From: Scott Castle [REDACTED]
Sent: 02 October 2019 10:00
To: Carol Reynolds <Carol.Reynolds@arun.gov.uk>
Cc: Anita Gardner <Anita.Gardner@arun.gov.uk>; [REDACTED]
Subject: RE: 22 Beach Road, Littlehampton.
Importance: High

Thank you for your report, Issue 1, dated 20th September 2019 in respect of Project Number J2707, (as attached), which was amended in the light of my previous comments and my E Mail 4th September 2019, as below.

From: Scott Castle [REDACTED]
Sent: 23 August 2019 16:19
To: Carol Reynolds <Carol.Reynolds@arun.gov.uk>
Cc: Darren Godfrey [REDACTED]
Subject: 22 Beach Road, Littlehampton.
Importance: High

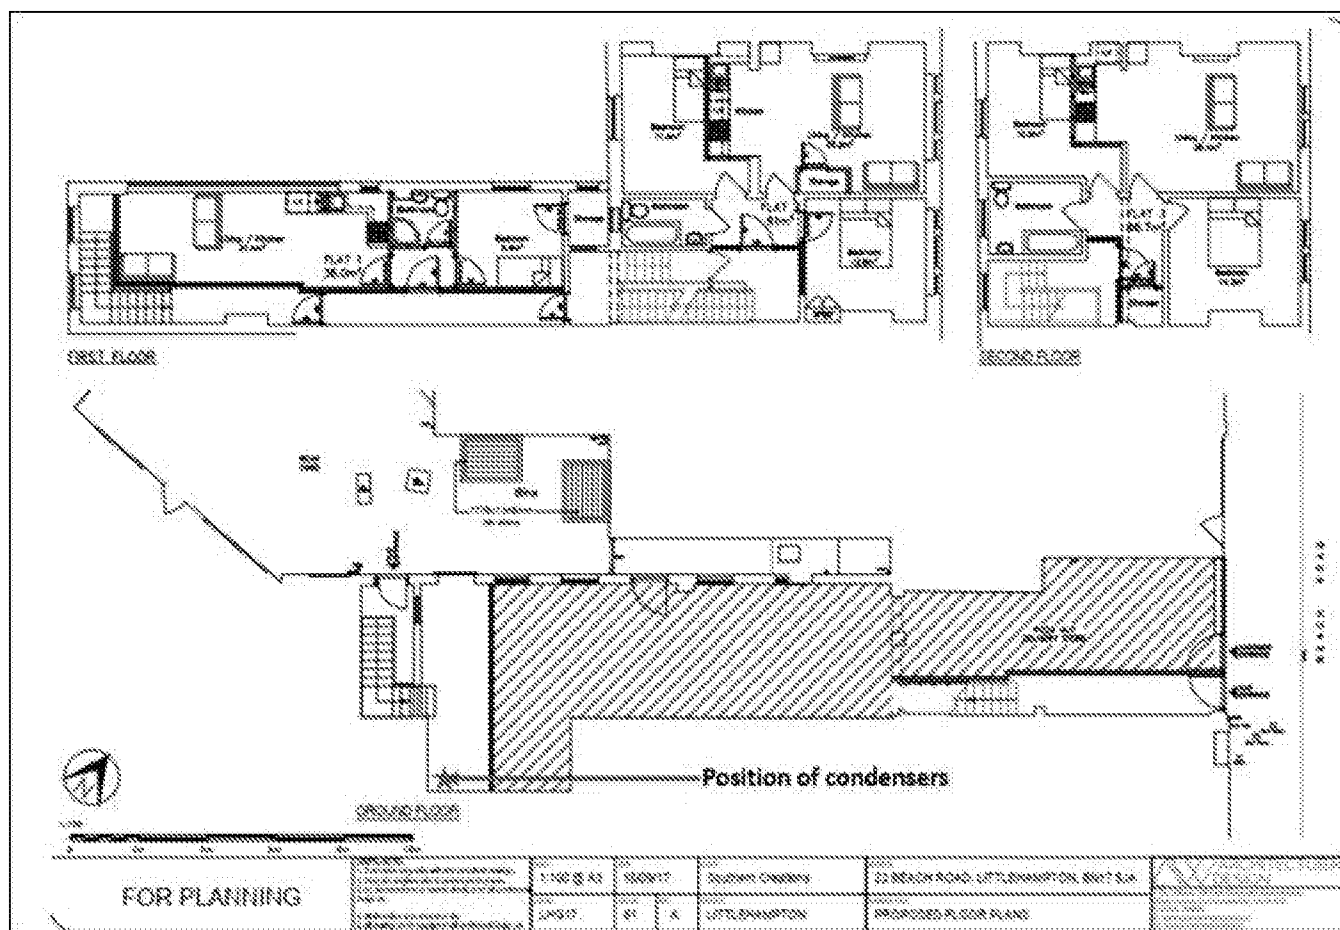
1. The condenser unit for the Walk in chiller.

The condensers were previously located below the bedroom window but have since been relocated to inside the rear garage unit at the very rear of Flat 1, outside the demise of the flat.

The condensers are mounted on anti-vibration mounts on the ground floor. Both the garage and the pizza hut ceiling were soundproofed at the same time. The condenser positions inside the garage void are shown below.
